## **MEMORANDUM**

**DATE:** October 25, 2012

**SUBJECT:** Zoning Commission # 12-09 – New Office building at 1111 New Jersey SE - Capital Gateway Overlay District-M Street Design Review (Square 743-N , Lots 78 and 834).

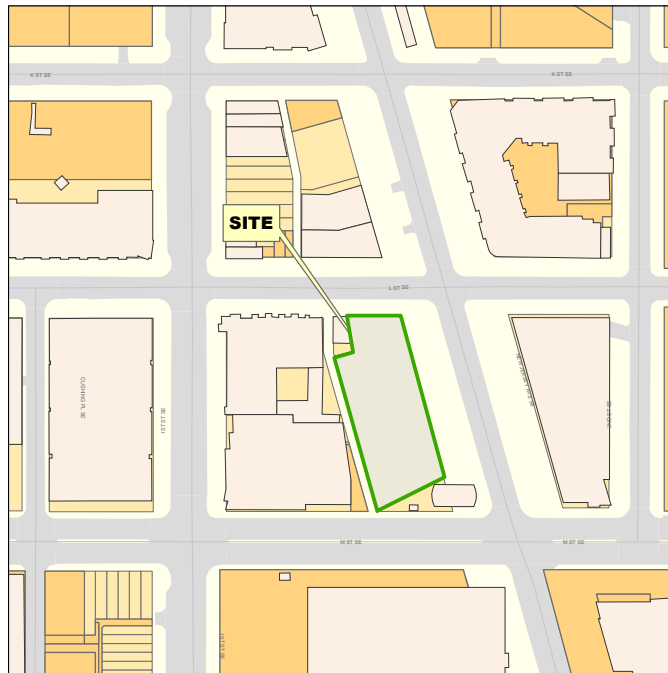
The Office of Planning (OP) supports the proposal for a 13-story residential development with ground floor retail as the proposal has generally incorporated and addressed most of the criteria of the Capitol Gateway Overlay. OP has requested that the applicant address the following issues prior to the public hearing:

- Lighting and retail signage;
- Relocation of PEPCO vaults;
- Improving the green building program to at least LEED Silver level;
- Integration of stormwater management features in the green areas along New Jersey Avenue;
- Bicycle rack location along New Jersey Avenue;
- Label areas of roof structure relief;
- Define accessory recreational use area; and
- L Street and alley façade improvement.
